GE Hitachi Nuclear Energy

MFN 09-110 S01 Docket No. 52-010

Subject: **Response to Portion of NRC Request for Additional Information Letter No. 325 Related to ESBWR Design Certificatin Application – RAI Number 6.1-12 S02**

RAI Number 6.1-12 S02

Figure 1: Schaeffler Diagram

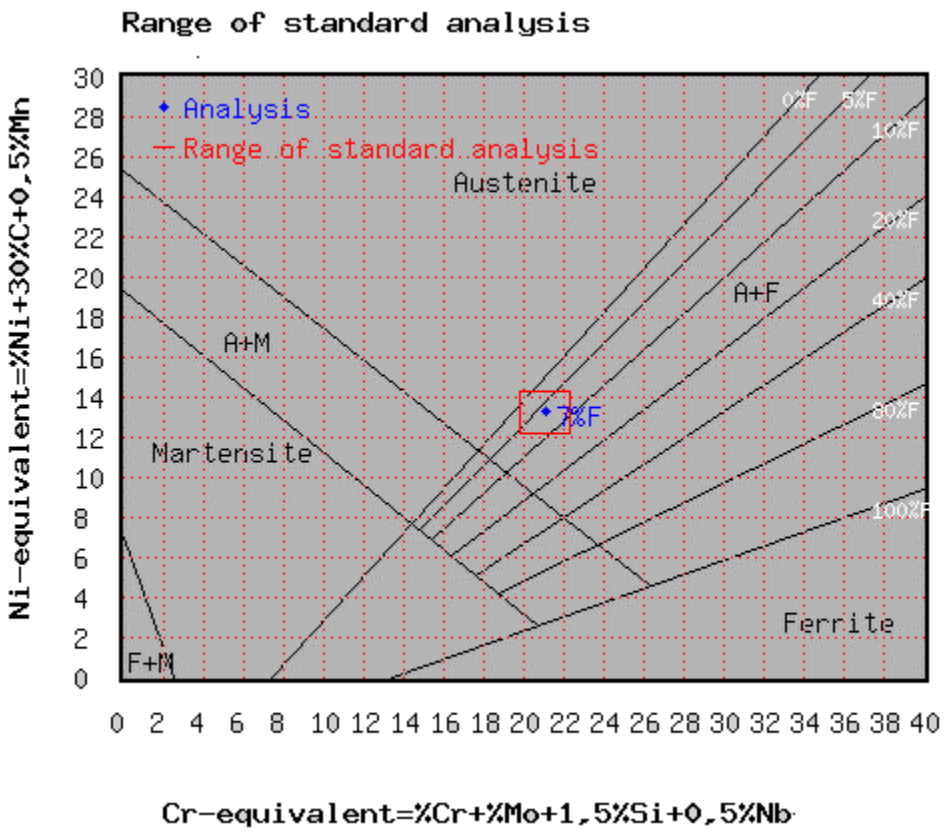
A. *The applicant stated that it will use E309 weld metal to perform dissimilar metal welds but did not discuss the history of joining HPS 70W to 304L using E309 or any other filler metal as requested by the staff. The staff notes that HPS 70W is a high performance steel generally used in bridge building. The staff is unaware of any testing of HPS 70W to stainless steel welds or any commercial applications that requires these two materials to be joined together. Therefore the staff requests that the applicant discuss the history of welding these two materials together. If no history is available, discuss your technical basis for welding these materials and confirmatory weld testing that you have performed.*

Several studies have been conducted to define the effect of combining alloy additions. One of the most recognized of these is the Schaeffler diagram [1]. The Schaeffler diagram can be used to predict the likely outcome of weld metal constituents when welding stainless steels to carbon steels. For example; the ESBWR containment design will require the joining of ASTM A 240 Type 304L [3] austenitic stainless steel A 709 HPS 70W plate per code case N-763. To determine the suitability of a Type 309L electrode [6] for this application, the Schaeffler Diagram is used in combination with the chemistry of the materials of construction. The chemical compositions are given for the plates and welding filler metal in Table 1 (Values are maximums, unless a range is specified).

The weld composite zone will encompass a mixture of weld filler metal and base metal. For the SMAW process, an approximately 30% base metal dilution is expected. Therefore, the resultant weld metal would be 70% filler metal chemistry with 15% HPS 70W plate chemistry and 15% 304 L Plate chemistry assuming equal fusion of base materials (Note: A 50/50 mixture is a common assumption as shown in AWS Handbook, Vol. 4, Ch 6) [2].)

To determine the weld metal constituents, the chromium and nickel equivalents tabulated in Tables 2A, 2B and 2C for filler metal and base metals for the welded joint are calculated as follows. The Chromium and Nickel equivalents are plotted in the Schaeffler diagram shown in Figure 1.

When the Cr and Ni equivalents are plotted on the Schaeffler diagram the weld deposit structure for the E309L electrode is austenite, and approximately 7 % ferrite with 30% dilution, (4% ferrite with 40% dilution). The expected dilution rate for Metal Arc Welding is 25- 40% and for SAW is 25-40%. Based on this evaluation, an E309L electrode is suitable for the joining of austenitic stainless steel to HPS 70W steel using SAW, SMAW or flux core welding processes.

Figure 2: Typical Weld Edge Preparation for Composite Plate.

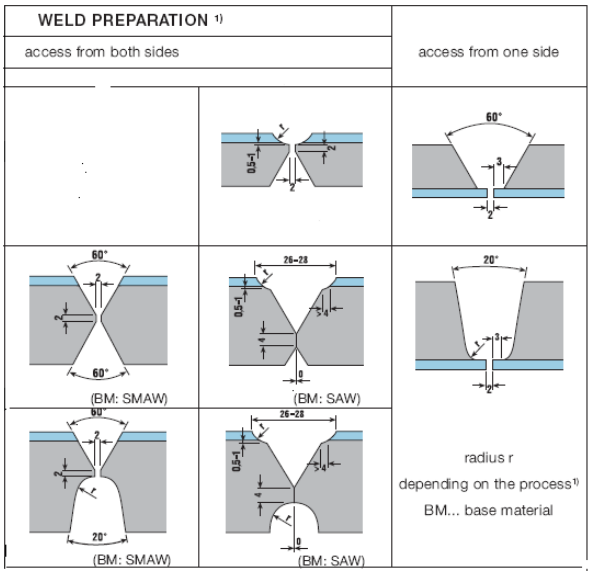
B. *The applicant's February 11, 2009 response stated that A709 HPS 70W liner plates will be cladded in accordance with SA-264. The applicant also stated that the exact cladding method (roll bonding, welding, etc.) will be determined in the construction phase. The staff notes that SA-264 does not address cladding of materials by welding other than cladding repairs. Therefore, the staff requests that the applicant address this inconsistency. In addition, describe the final heat treatment of the finished clad product and identify the testing requirements to ensure that the HPS 70W material retains its mechanical properties and the stainless steel cladding retains its corrosion resistance.*

(B) As noted in the February 11, 2009 response, the exact method for cladding of the HPS 70W will be determined at the construction phase. The two methods for forming of the clad steel plate are discussed below.

<u>Weld cladding</u>: GEH agrees that the SA-264 does not address weld overlay of 304 L material by welding. If the weld overlay method is used to fabricate portions of the containment structure, HPS 70W material will be clad in accordance with the requirements of the applicable codes and standards.

Figure 2 is a schematic of typical weld joints used in the fabrication of clad steel plates.
